PROJECT NUMBER: SP2024-009
PROJECT NAME: Amended Site Plan for 1775 State Highway 276
SITE ADDRESS/LOCATIONS: 1775 STATE HIGHWAY 276, ROCKWALL, 75032

CASE CAPTION: Discuss and consider a request by Justin Toon of Industrial Reserve on behalf Reserve Capital – Rockwall Industrial SPE, LLC for the approval of an Amended Site Plan for a Warehouse/Distribution Center on an 18.48-acre tract of land identified as Tracts 1, 1-3 & 1-7 of the J. M. Allen Survey, Abstract No. 2, City of Rockwall, Rockwall County, Texas, zoned Light Industrial (LI) District, situated within the SH-276 Overlay (SH-276 OV) District, addressed as 1725 SH-276, and take any action necessary.

DEPARTMENT	REVIEWER	DATE OF REVIEW	STATUS OF PROJECT
PLANNING	Bethany Ross	03/20/2024	Approved w/ Comments

Project No.:	53955
Issued:	MARCH, 2024
Drawn By:	CAD
Checked By:	MJG
Scale:	AS SHOWN
Sheet Title	SITE PLAN
Sheet Number	SP1.01

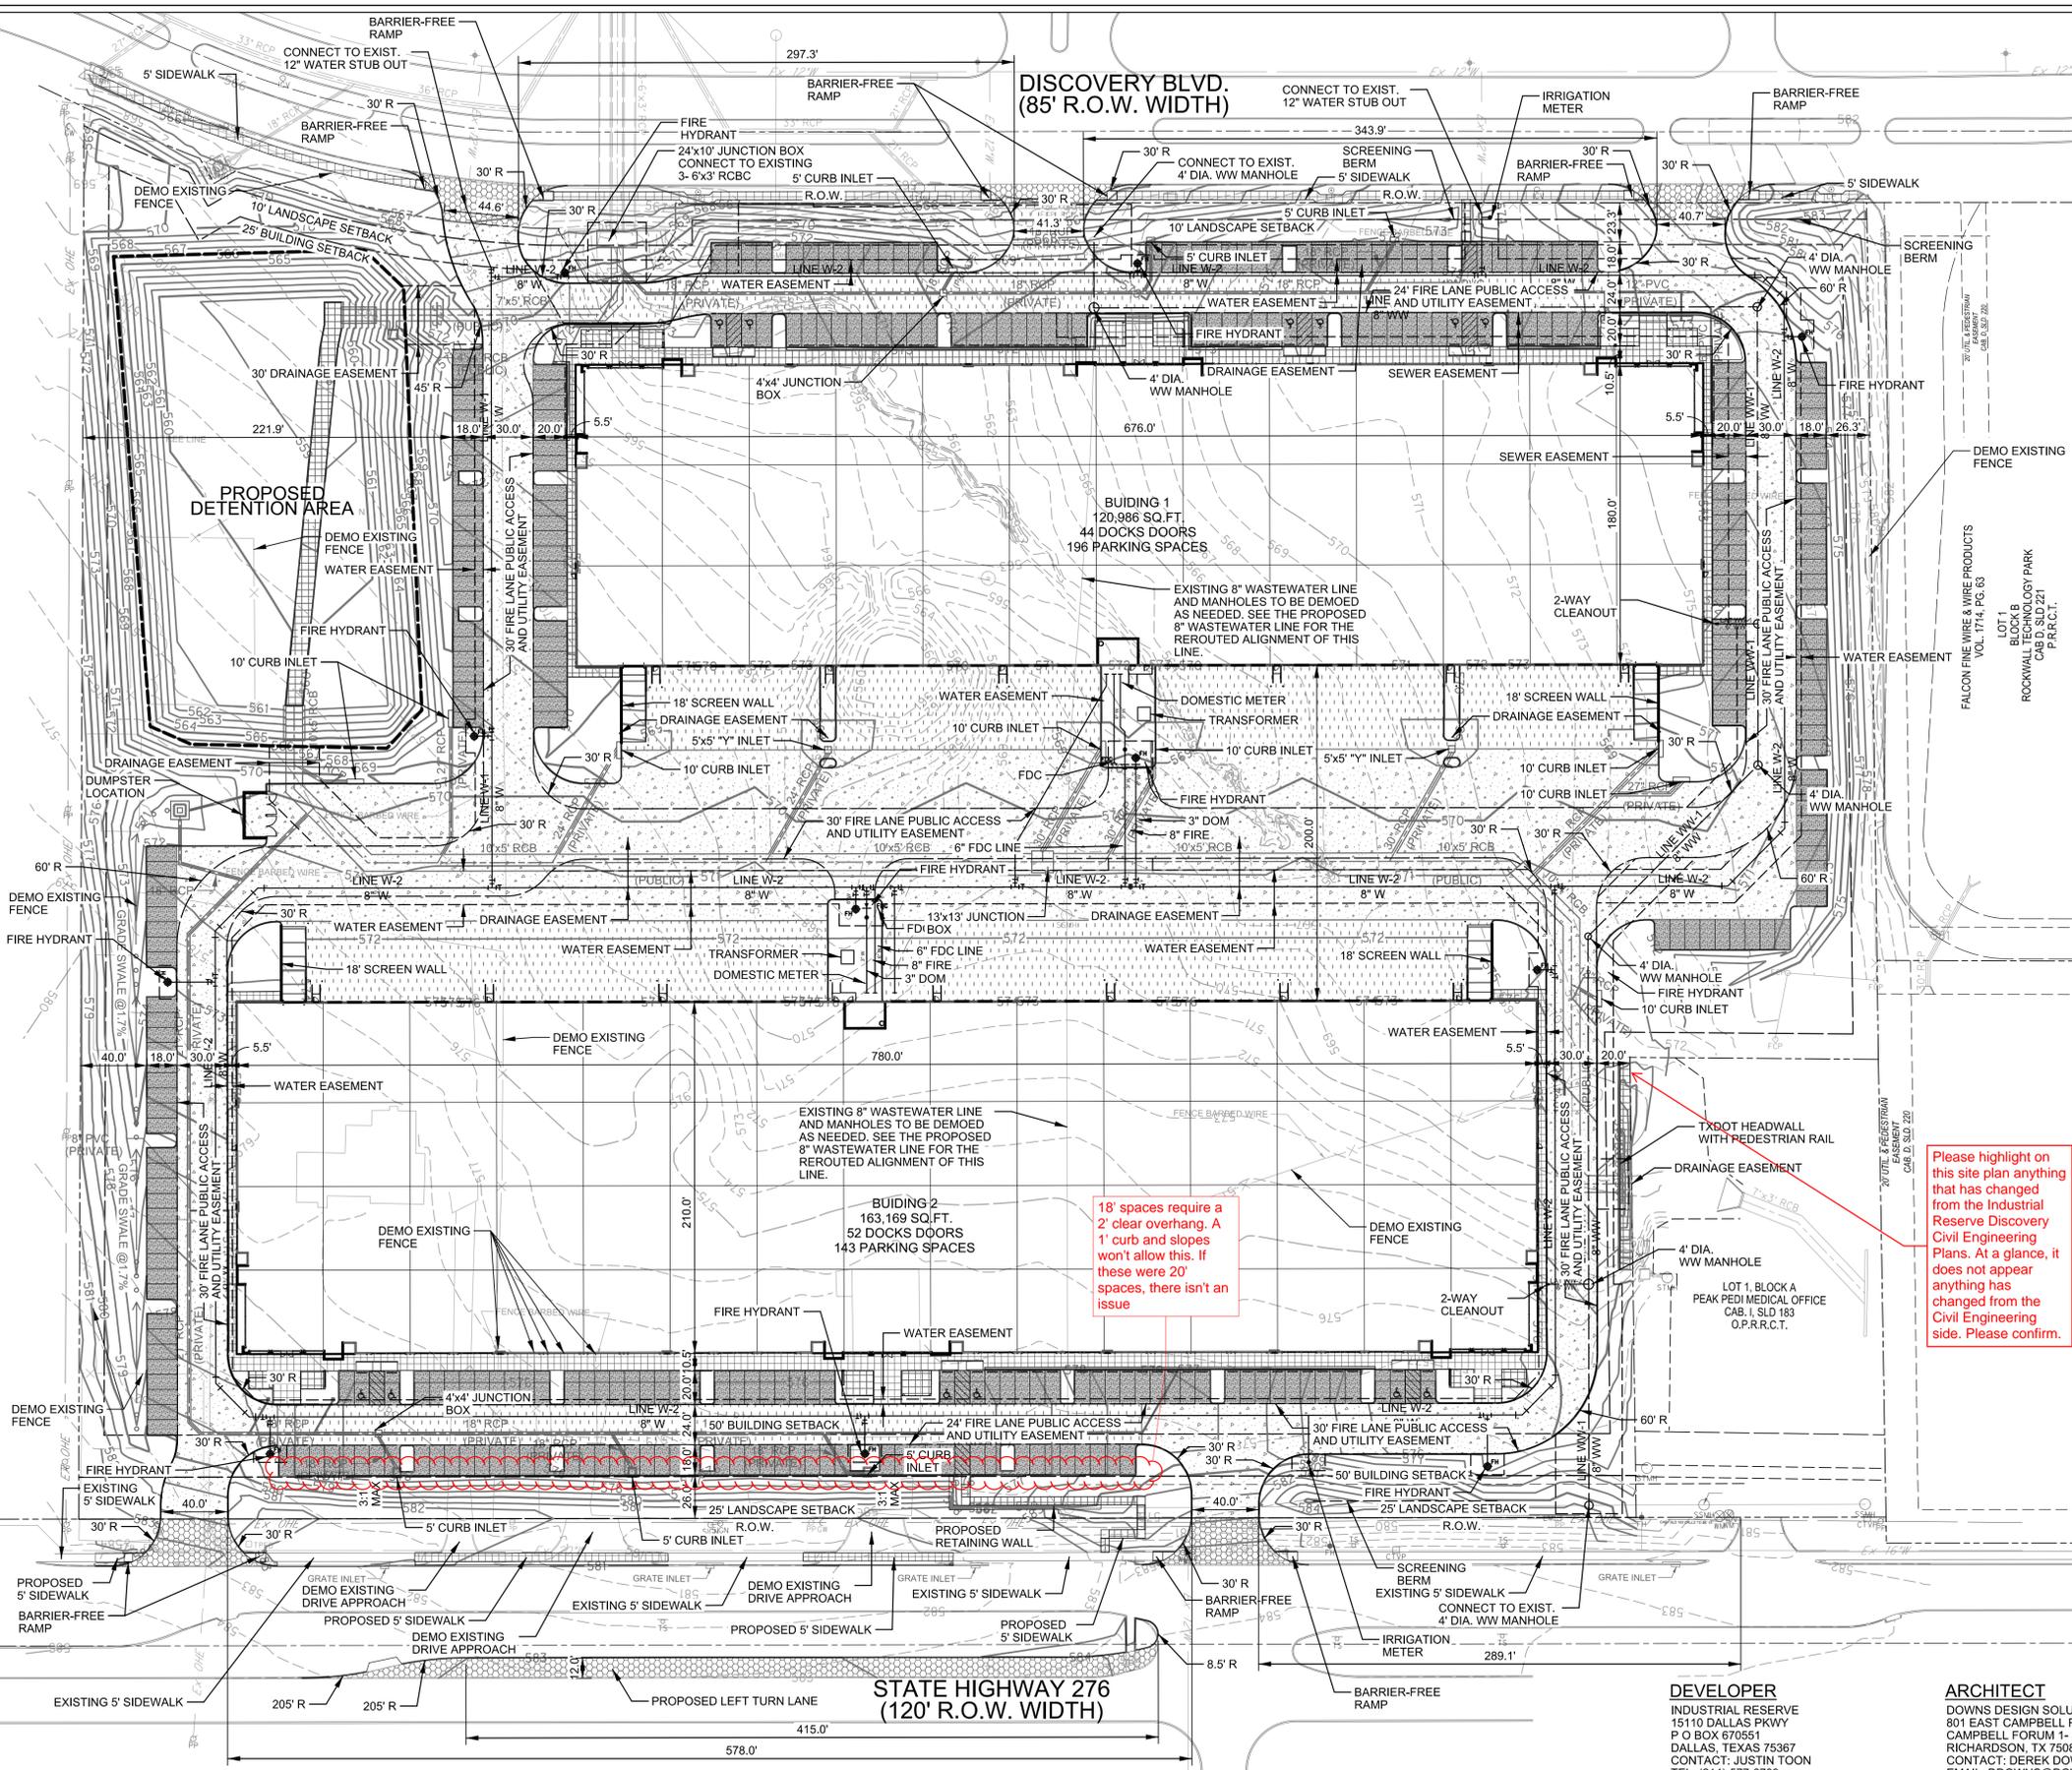
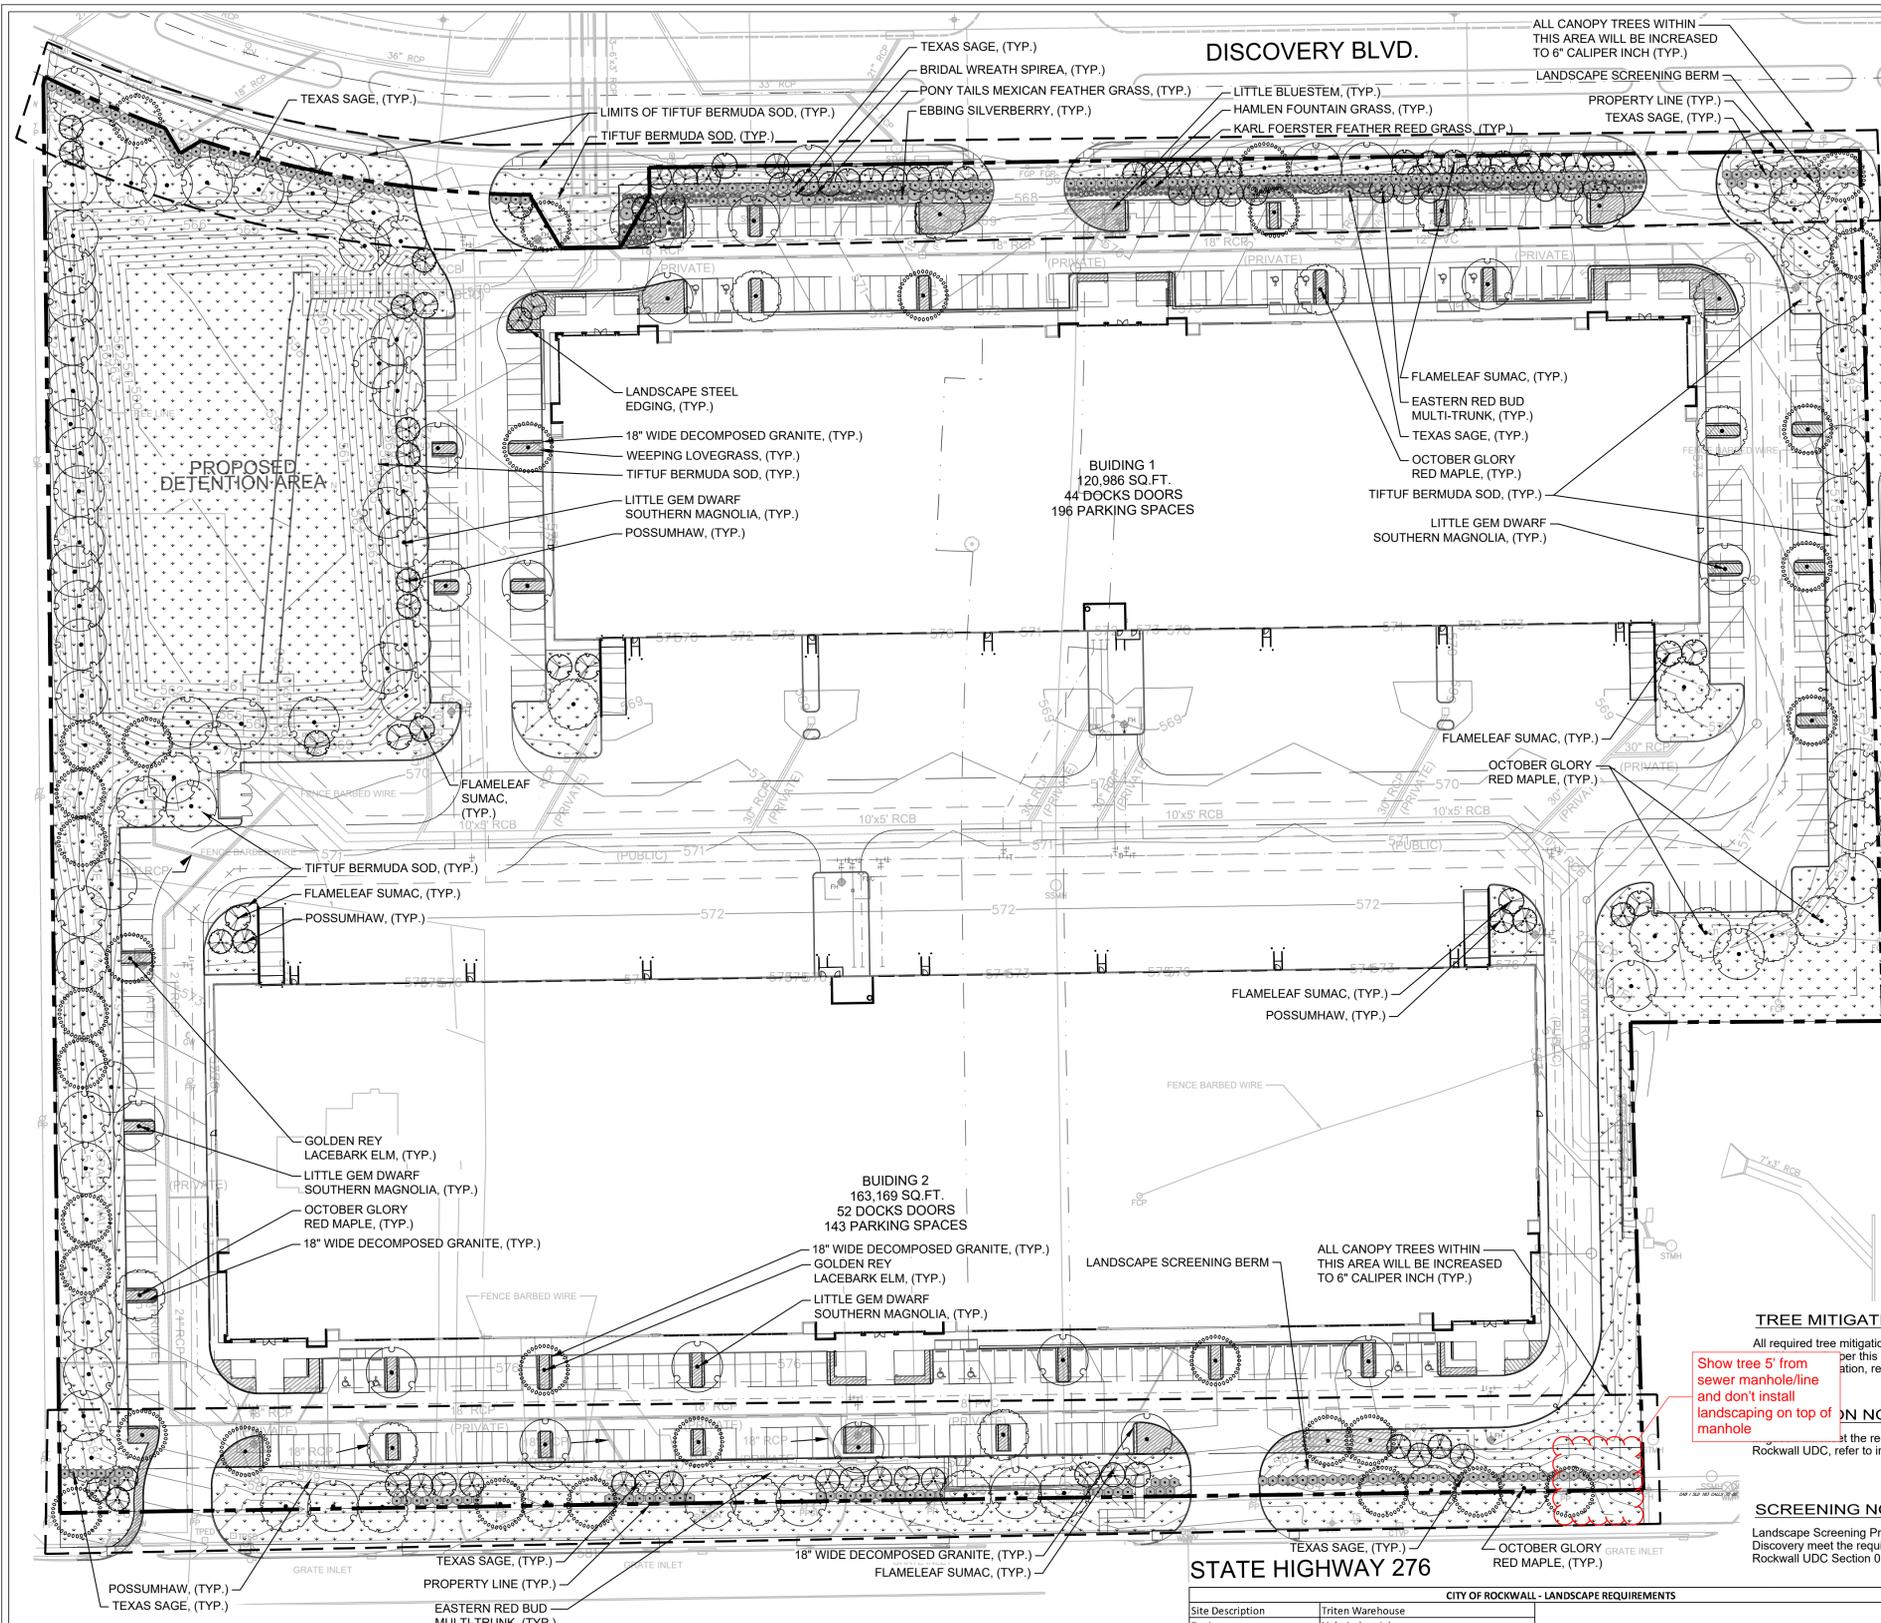
- 03/21/2024: 1. 18' spaces require a 2' clear overhang. A 1' curb and slopes won't allow this. If these were 20' spaces, there isn't an issue
2. Please highlight on this site plan anything that has changed from the Industrial Reserve Discovery Civil Engineering Plans. At a glance, it does not appear anything has changed from the Civil Engineering side. Please confirm.
 3. Show tree 5' from sewer manhole/line and don't install landscaping on top of manhole
 4. 18' parking spaces to have 2' clear overhang

- Roadway Paving Items:**
- Must meet City driveway spacing requirements.
 - All parking, storage, drive aisles must be reinforced concrete. (No rock, gravel, or asphalt allowed).
 - All Parking to be 20'x9' minimum. Parking may not be off a public Roadway. Vehicle must not be required to back onto a public roadway, including trash trucks.
 - No dead-end parking allowed without an City approved turnaround.
 - Drive aisles to be 24' wide.
 - Fire lane (if needed) to be 24' wide and in a platted easement.
 - Fire lane (if needed) to have 20' min radius if buildings are less than 30' tall. If any of the buildings are 30' or more, the fire lane will be 30' radius minimum.

- Landscaping:**
- No trees to be with 10' of any public water, sewer or storm line that is 10" in diameter or larger.
 - No trees to be with 5' of any public water, sewer, or storm line that is less than 10".

18" spaces require a 2' clear overhang. A 1' curb and slopes won't allow this. If these were 20" spaces, there isn't an issue
